C/ 1 SC 1.4 Stewart, Heath	<i>Р</i> <b>20</b> LTC	L <b>35</b>	# 126	C/ 33 SC 1.4 Lukacs, Miklos	P <b>46</b> Silicon Labs	L <b>6</b>	# 89
Comment Type <b>T</b> Number of specified F	Comment Status X PD configurations may be redu	ced.		Comment Type E The title of the clau	Comment Status X use refers to Type 1 and 2 only.		
SuggestedRemedy See stewart_2_0116. Proposed Response	pdf Response Status <b>O</b>			SuggestedRemedy Replace the title wi System parameter Proposed Response			
C/ 25 SC 25.4.5 Yseboodt, Lennart	P <b>24</b> Philips	L 1	# 168	C/ 33 SC 1.4 Lukacs, Miklos	P <b>46</b> Silicon Labs	L 9	# 90
greater PD (see Clau	Comment Status X ASE-TX receiver in a Type 2 o use 33) shall meet the requirem es are included with the phrase ed.	ents of 25.4.7."		not mentioned any	Comment Status X about that PSEs and PDs are cate how in the refernced tables (table e the reader may think that the bas	33-1, below the	e text). This is

COMMENT STATUS: D/dispatched A/accepted R/rejected RESPONSE STATUS: O/open W/written C/closed Z/withdrawn SC 33.2.0a 1/11/2016 10:45:29 AM SORT ORDER: Clause, Subclause, page, line

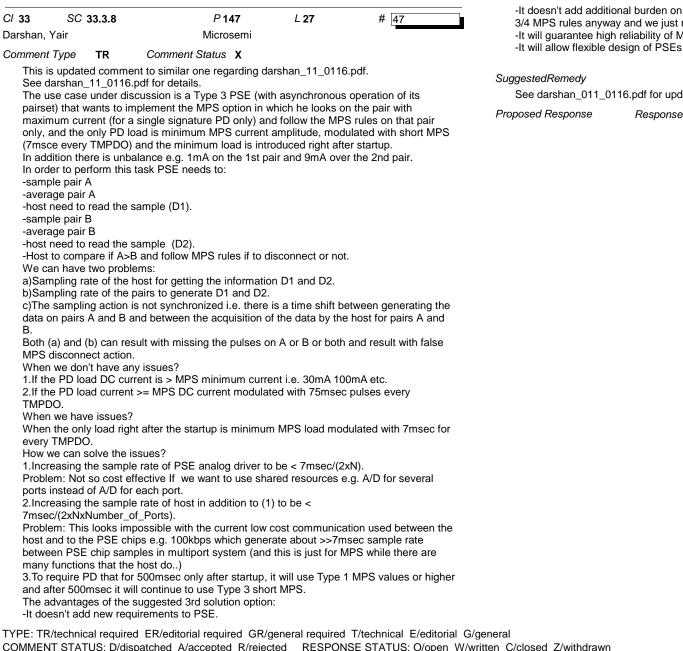
I assume PDs that want to be very power efficient would draw close to 0 current that would be swamped by the current drawn by Rpd\_d of Table 33-19. Only Type 3 and 4 PDs are provided requirements for Autoclassification.

The text, "or a PD which does not detect a long first class event" grants new PD Types with Autoclassification an allowance that would break compatibility legacy AC disconnect PSEs.

Task Force should discuss the implications of this. The preferred solution is replace the referenced text with,
